PROJECT SCOPING PLAN FOR PREFORMING A
CERCLA REMEDIAL INVESTIGATION/FEASIBILITY
STUDY (RI/FS) AT THE PESTICIDE STORAGE AREA
NEAR BUILDINGS 5 AND 6, SENECA ARMY DEPOT
ACTIVITY

**PROJECT SCOPING PLAN
REMEDIAL INVESTIGATION/FEASIBILITY STUDY
AT SEAD-66
SENECA ARMY DEPOT ACTIVITY
ROMULUS, NEW YORK**

**COMMENTS AND RECOMMENDATIONS
PRE-DRAFT PROJECT SCOPING PLAN
REMEDIAL INVESTIGATION FEASIBILITY STUDY
PESTICIDE STORAGE AREA NEAR BUILDING 5 AND 6 (SEAD-66)
SENECA ARMY DEPOT
ROMULUS, NEW YORK
FEBRUARY 1995**

FIGURE 1-2
SEAD-66 SITE PLAN

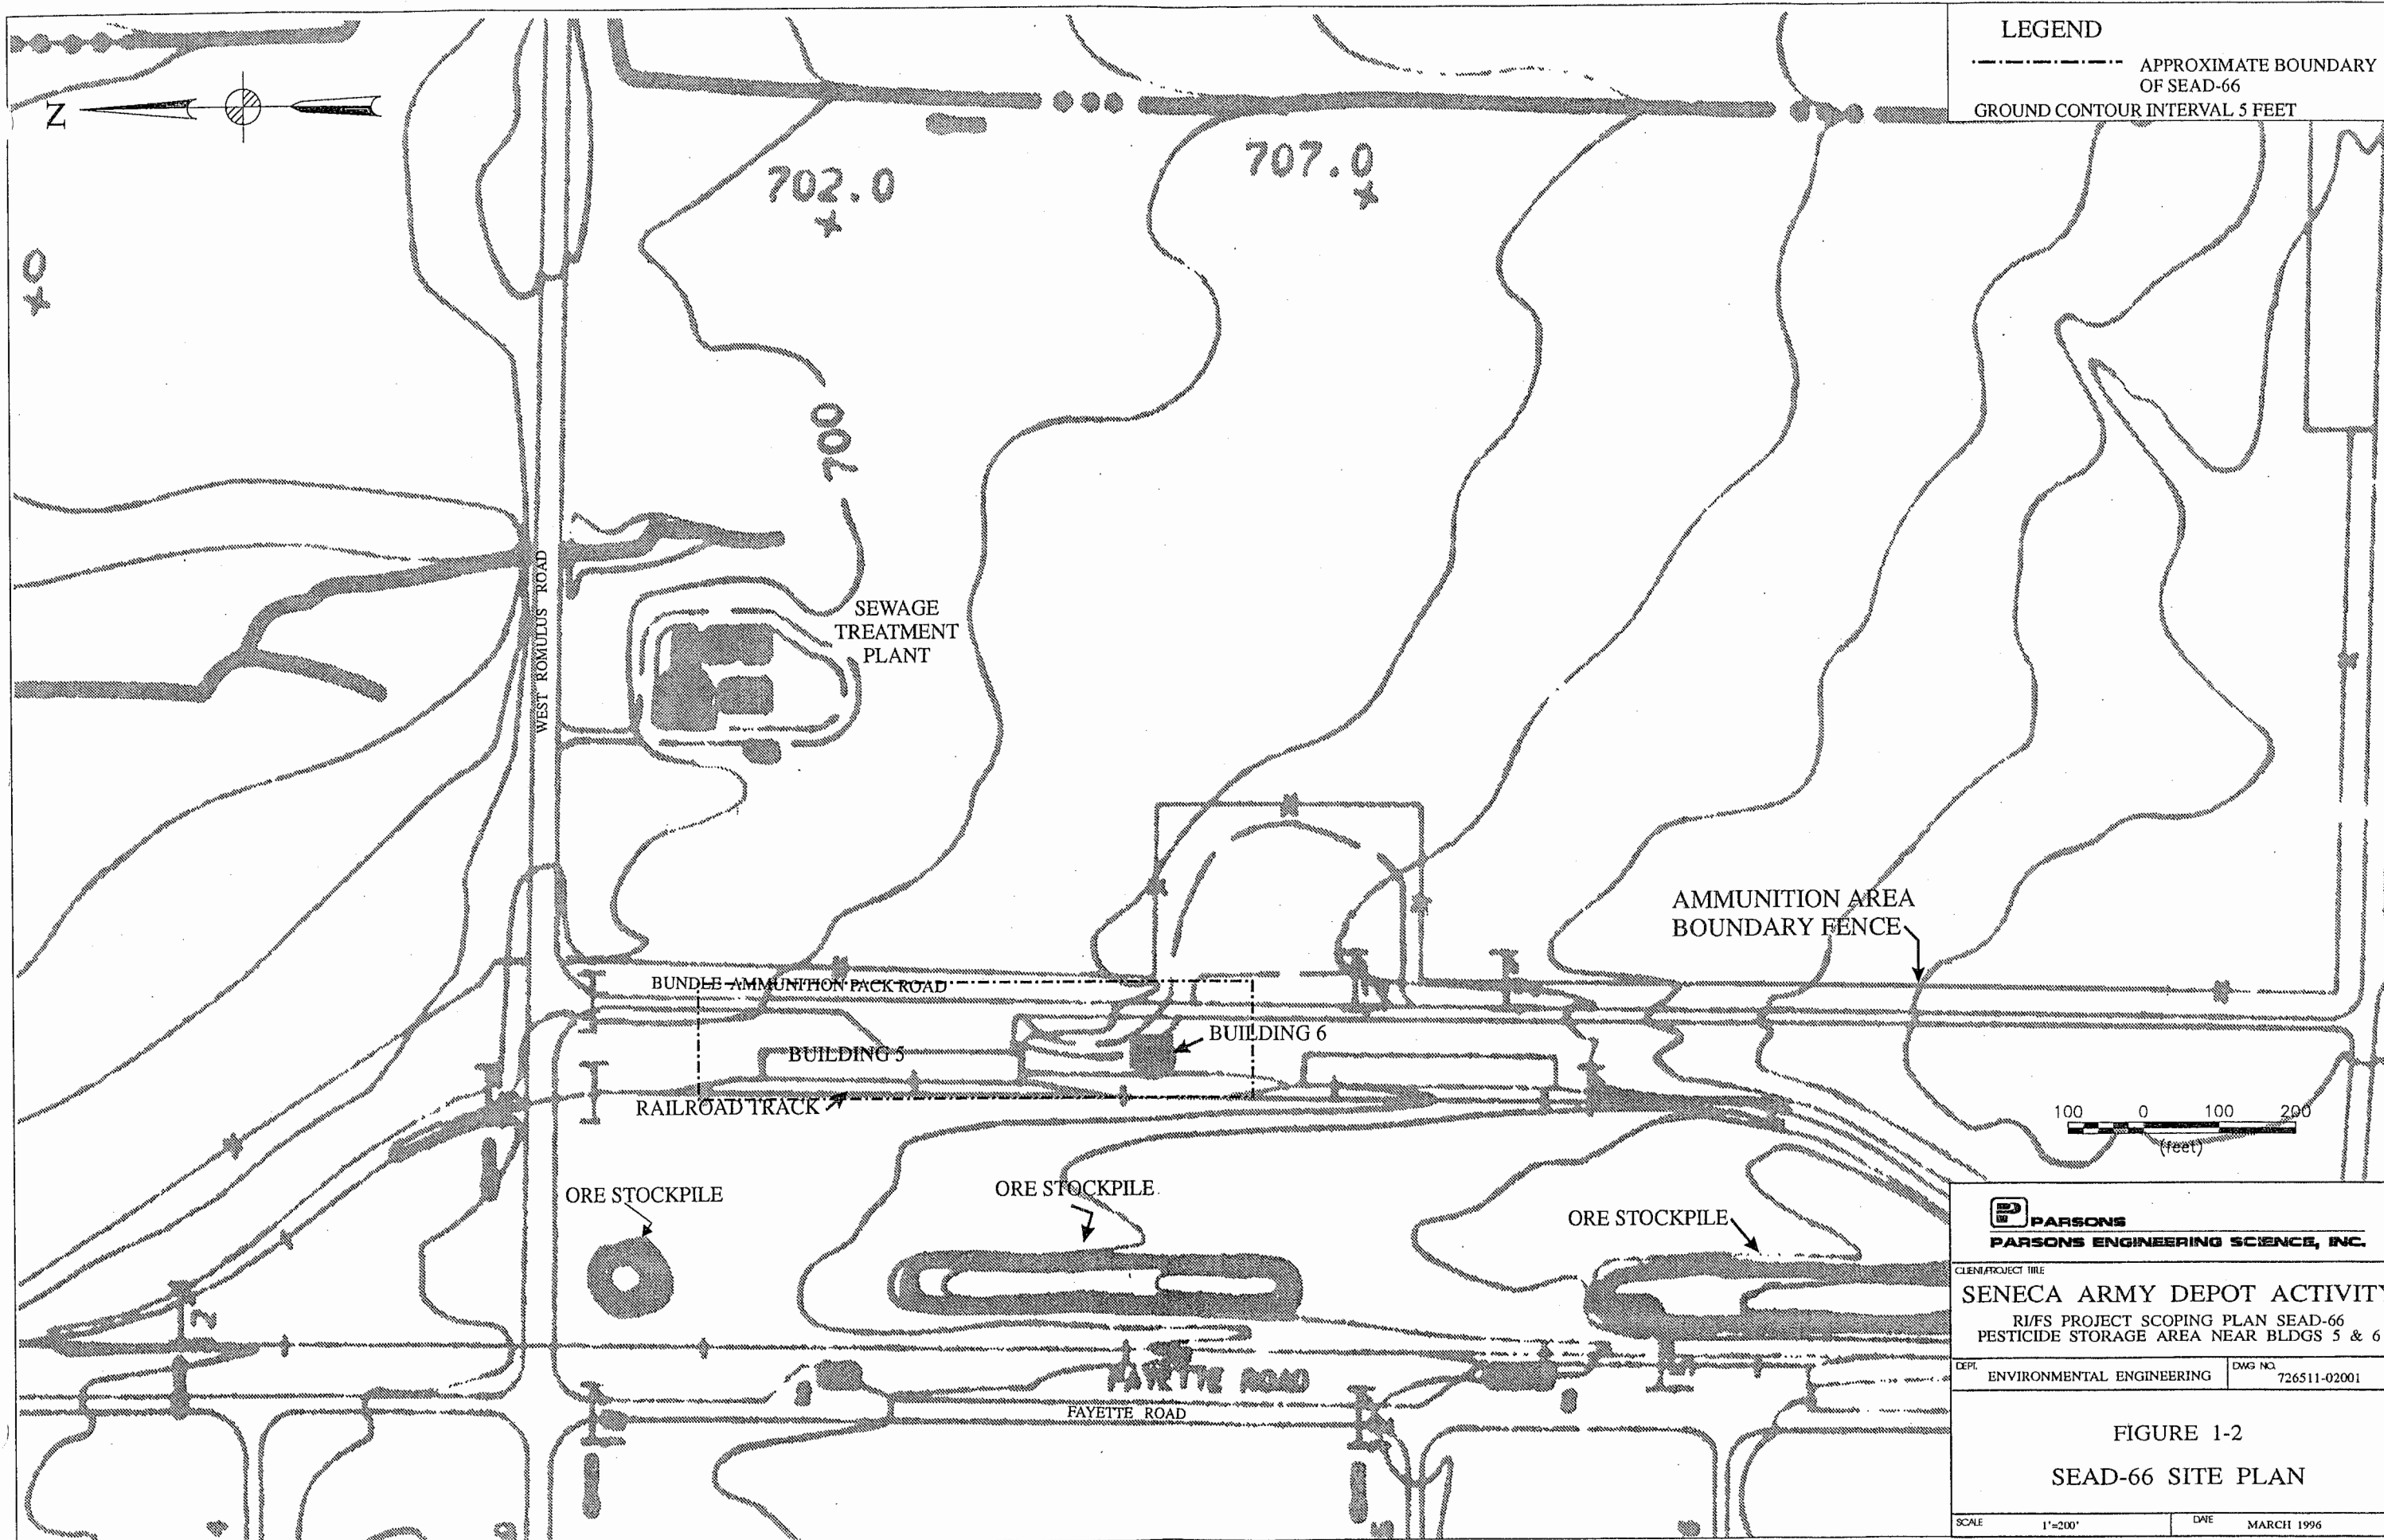
One of the proposed monitoring well sites appears to be located in the center of the Pesticide Storage Area, as illustrated in Figure 1-2. If the borehole for this well is drilled through soil that contains pesticides, the potential exists for contamination of ground water by constructing a conduit through which contaminants can migrate.

Agree. The figure needs clarification. The arrow in Figure 1-2 was pointing to the general area "near Buildings 5 and 6" that comprises SEAD-66, not a specific source of contamination. However, to clarify the location of the AOC, Figure 1-2 has been changed so that the arrow has been deleted and a dashed line has been drawn around the approximate boundaries of the AOC. Three of the monitoring well locations have also been moved to more downgradient locations.

FIGURE 3-2
EXPOSURE PATHWAY SUMMARY

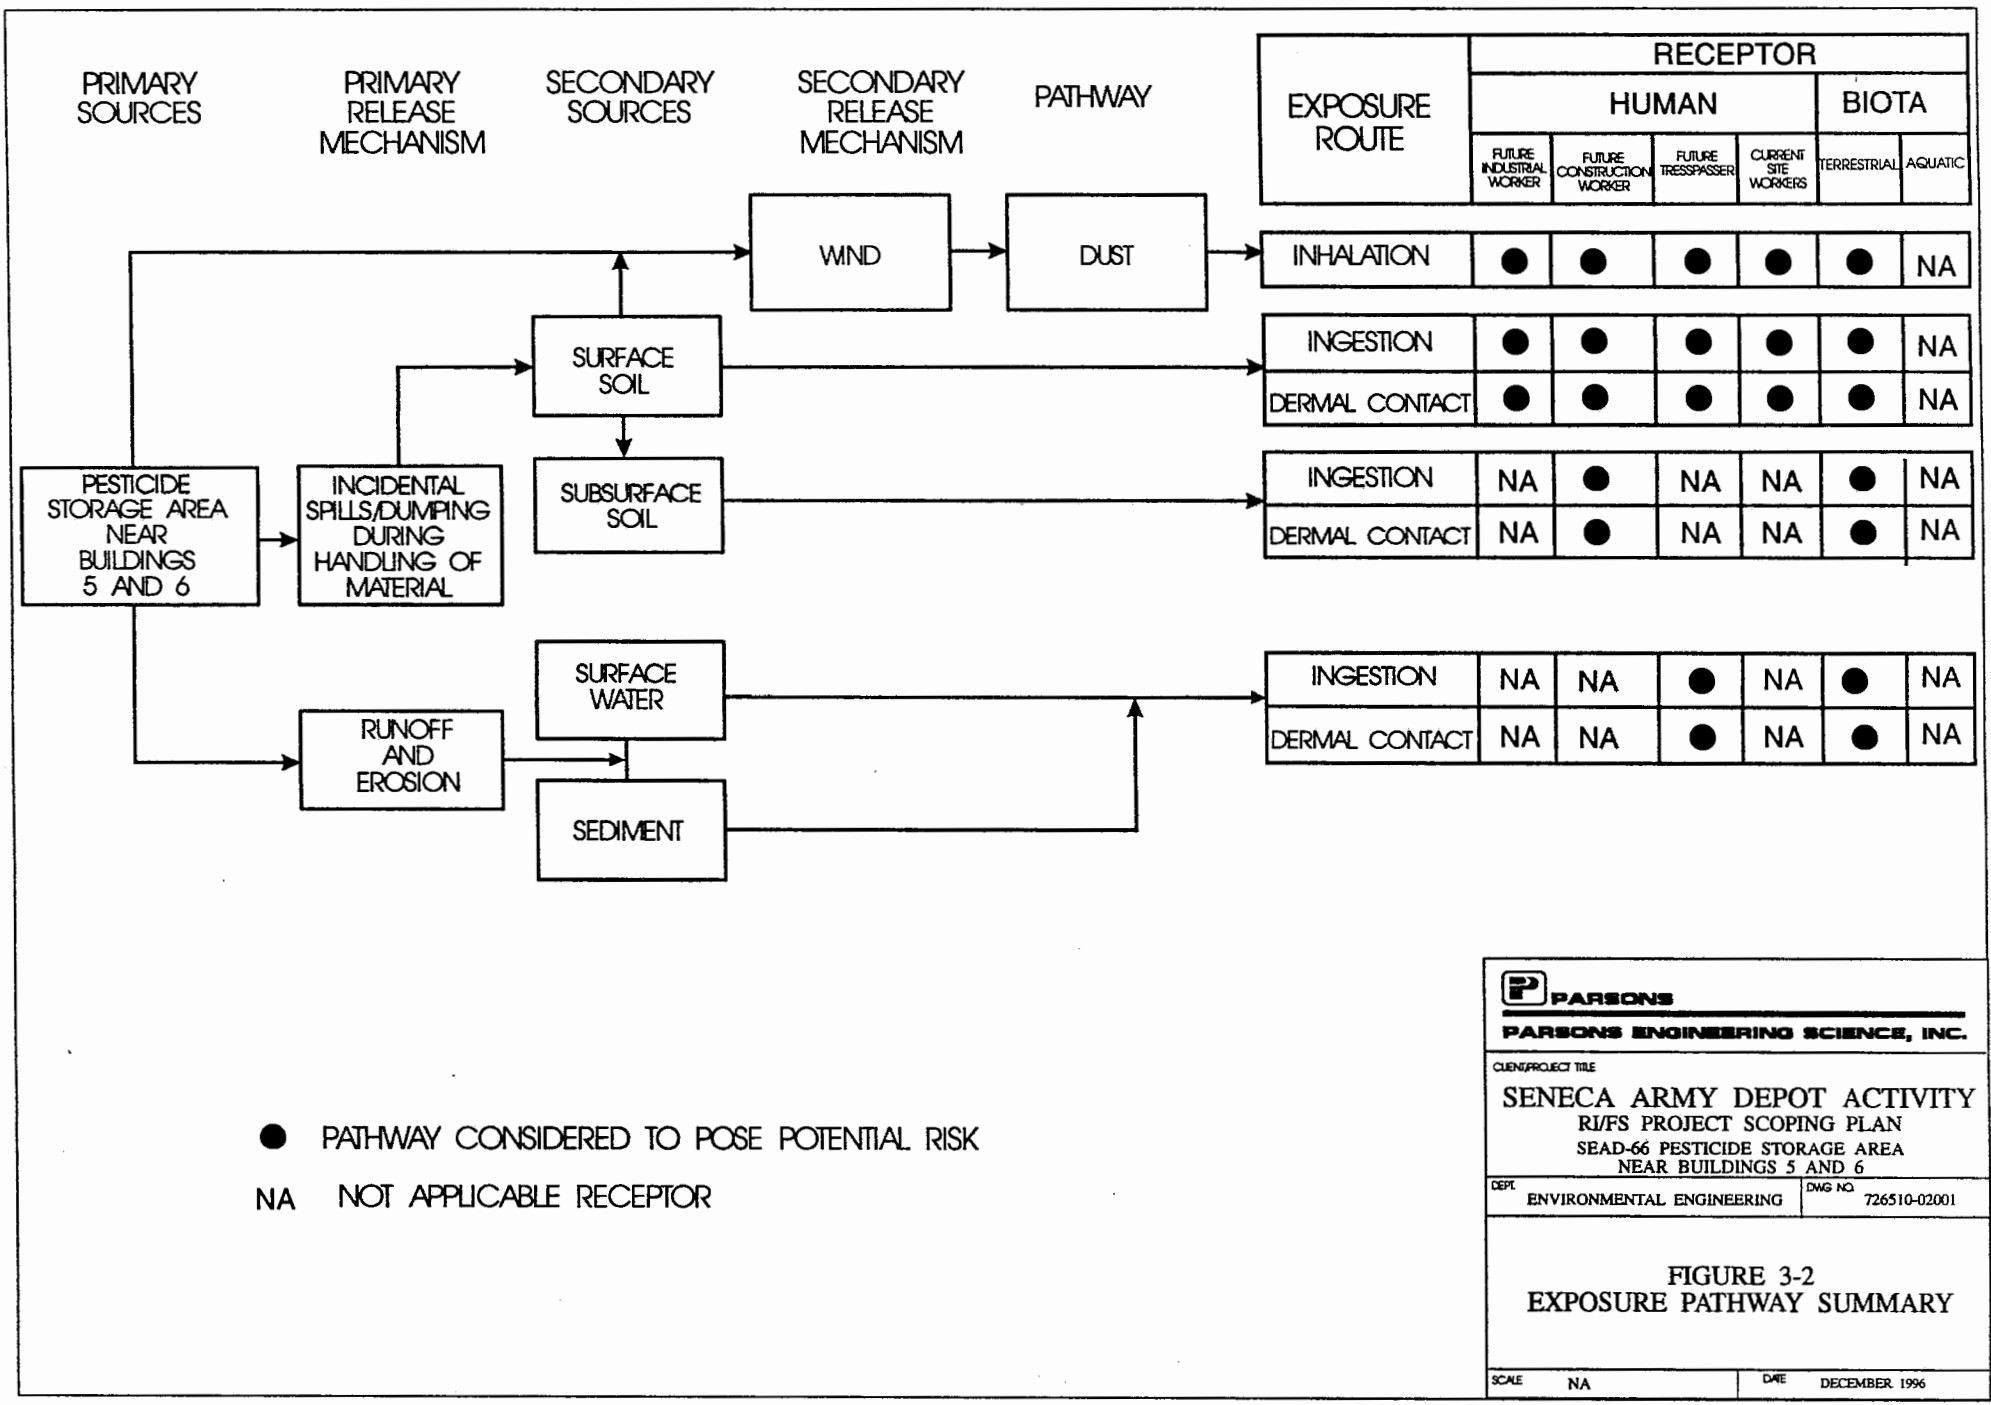
Comment #7

Response #7

Agreed. Figure 3-2 (formerly Figure 3-1) has been modified to include ingestion of soil by workers.

Agreed. Visitors have been added to the CSM Figure 3-2 (formerly Figure 3-1).

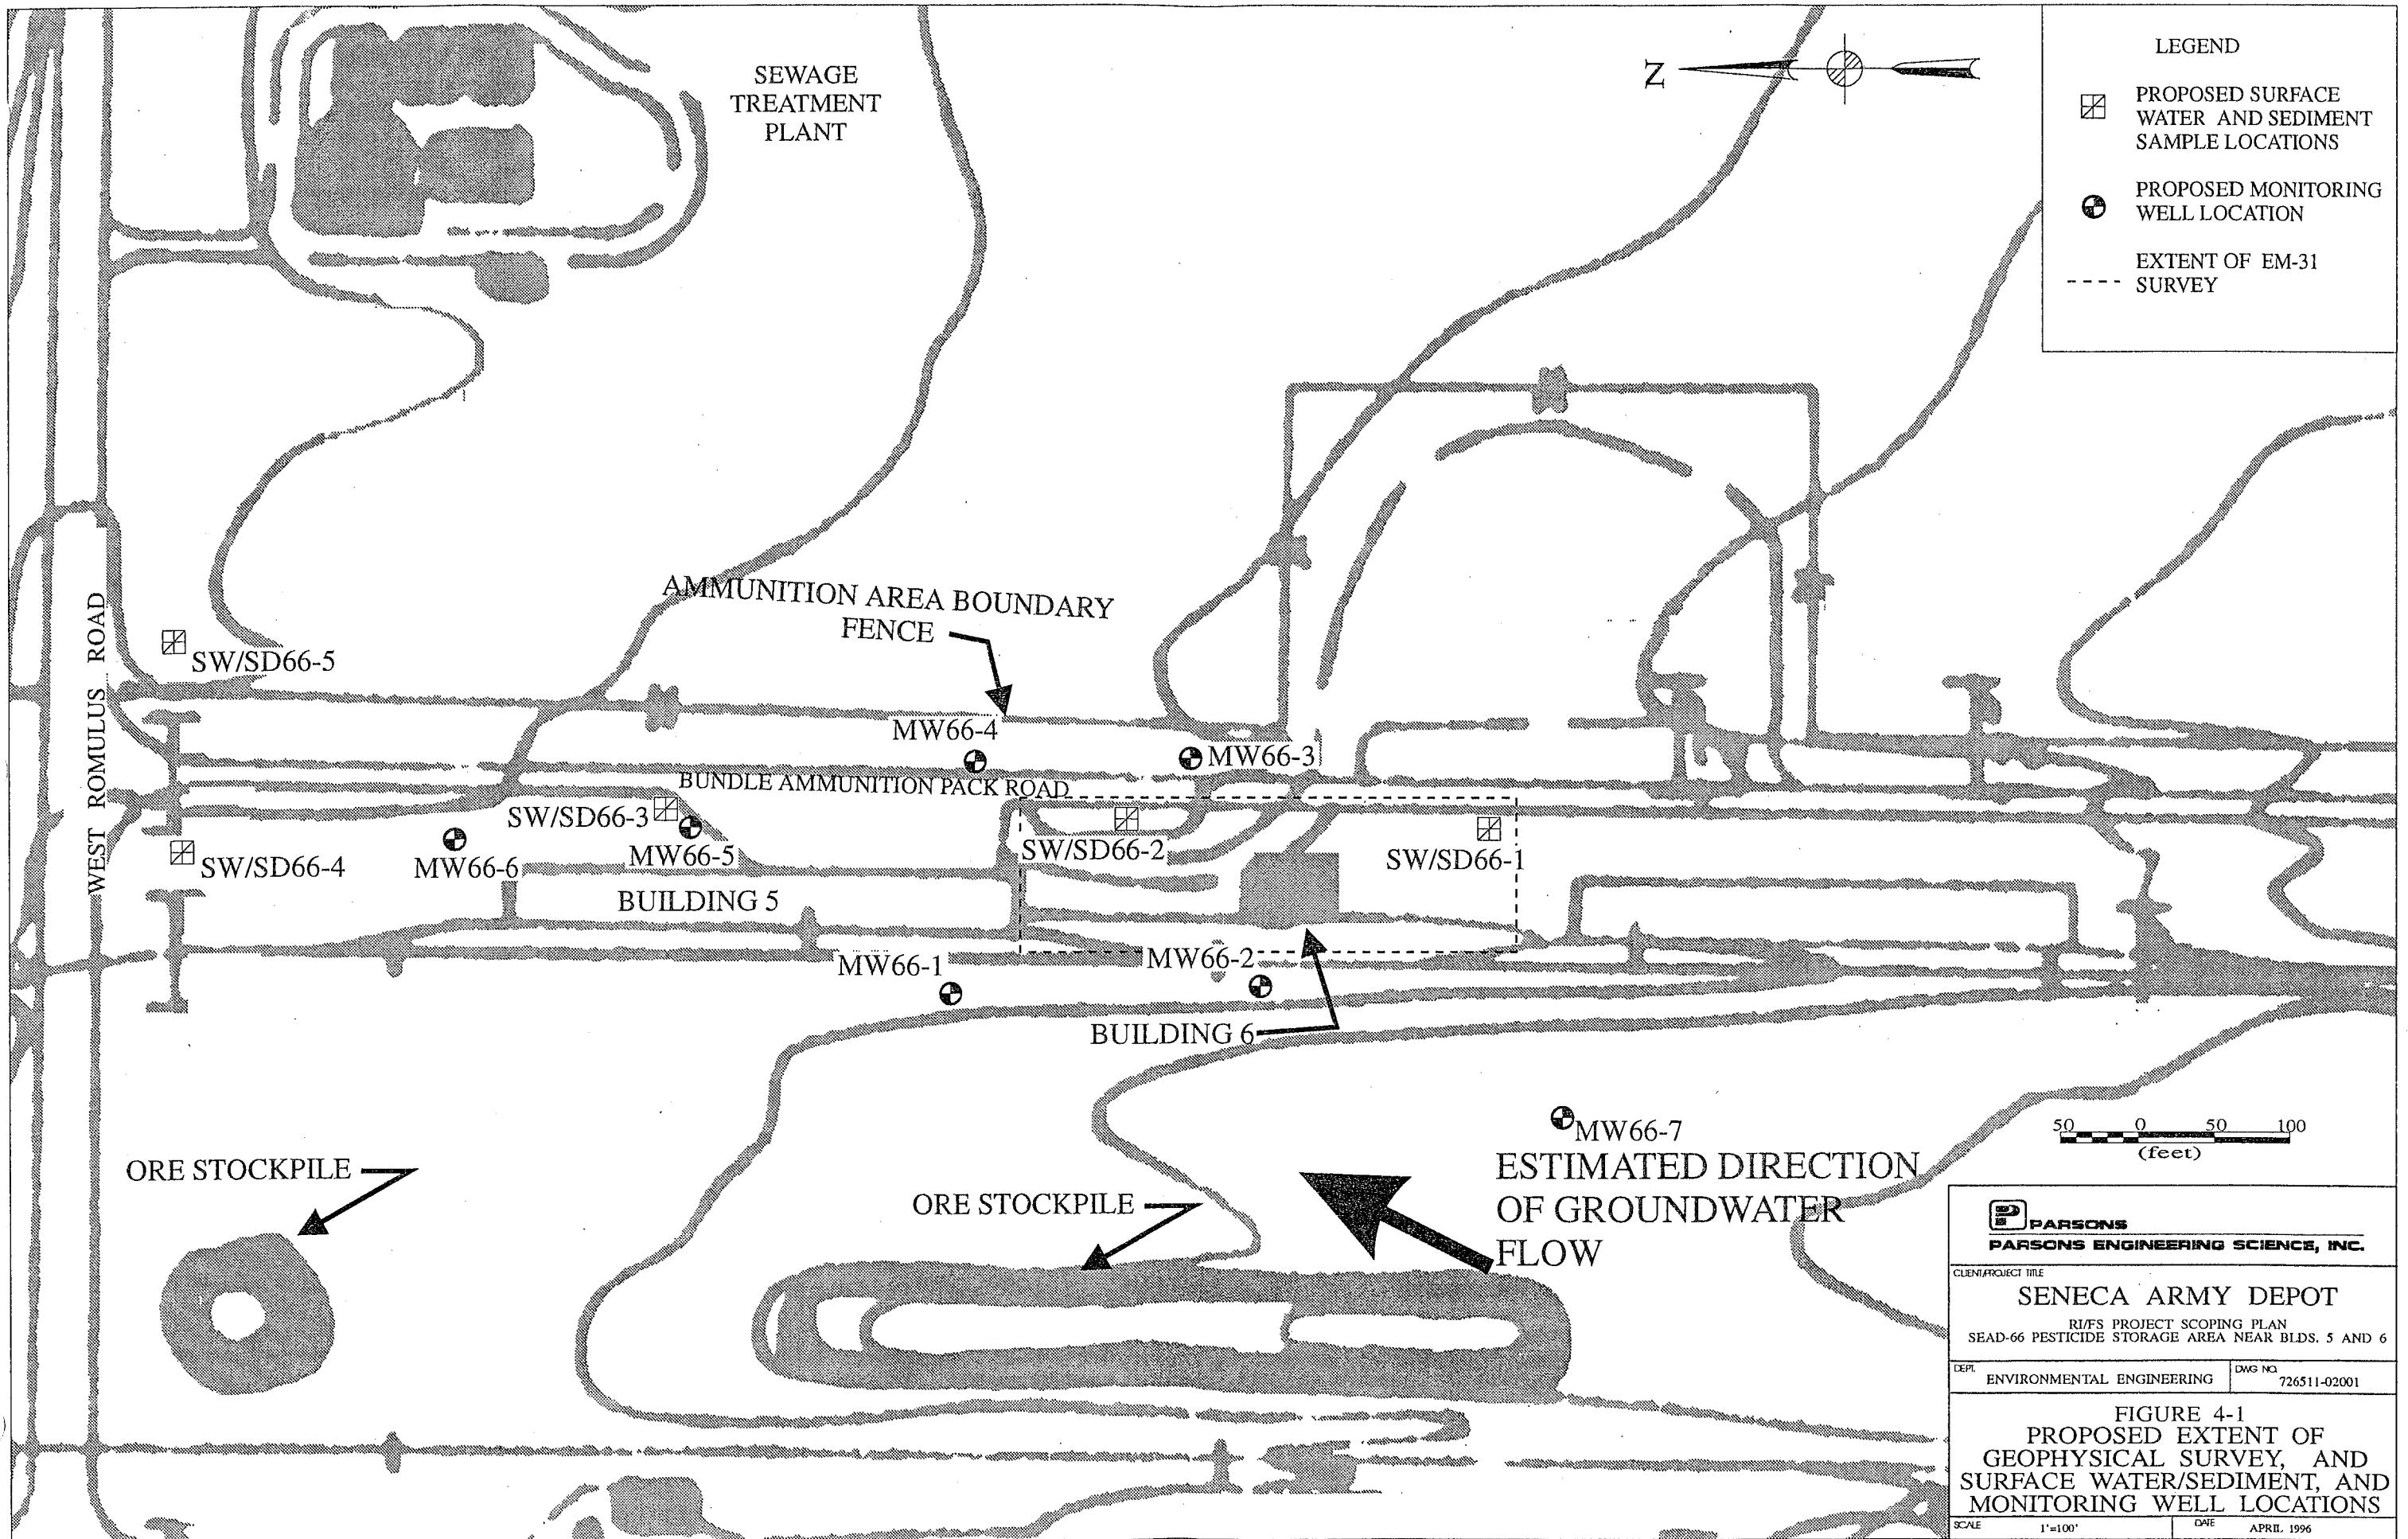
Comment #4

Page 4-2, Figure 4-1, Proposed Sample Locations.

Response #4
